AEP-NRC-2014-90  
10 CFR 50.4

Donald C. Cook Nuclear Plant Units 1 and 2  
Compliance with March 12, 2012, U. S. Nuclear Regulatory Commission (NRC) Order  
Regarding Reliable Spent Fuel Pool Instrumentation (Order Number EA-12-051)

### Responses to Requests for Additional Information

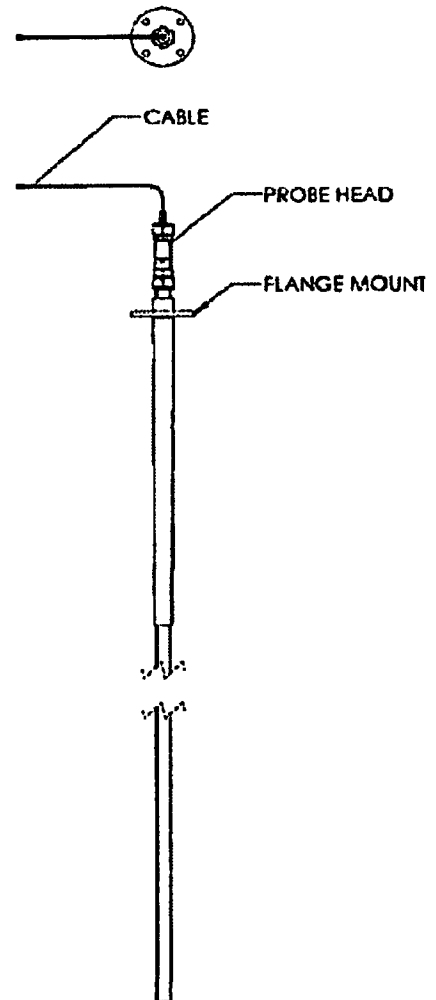
**RAI #3(a)**

- a) *The design criteria that will be used to estimate the total loading on the mounting device(s), including static weight loads and dynamic loads. Describe the methodology that will be used to estimate the total loading, inclusive of design basis maximum seismic loads and the hydrodynamic loads that could result from pool sloshing or other effects that could accompany such seismic forces.*

The design criteria used to estimate the total loading on the mounting device(s), including static weight loads and dynamic loads uses a bounding seismic case. The bounding seismic case consists of a range of four seismic cases and is analyzed from the CNP response spectrum. The seismic case that induces maximum lateral velocities local to the probe, as well as maximum vertical velocities which may impact the probe mount is identified as the bounding single frequency case. Time History analysis, a type of multiple-frequency testing, provides a closer simulation of typical seismic motion without introducing a higher degree of conservatism.

The methodology used to estimate the total loading, inclusive of design basis maximum seismic loads and the hydrodynamic loads that could result from pool sloshing or other effects that could accompany such seismic forces, is contained in 1-0410-9, "MOHR SFP-1 Level Probe Assembly Seismic Analysis Report." This calculation was performed using a detailed 3D CAD fluid-structure interaction model of the probe using the ANSYS Mechanical APDL software package. Seismic excitation made use of the artificial earthquake time histories enveloping the 5.384 g reference (target) required response spectrum.
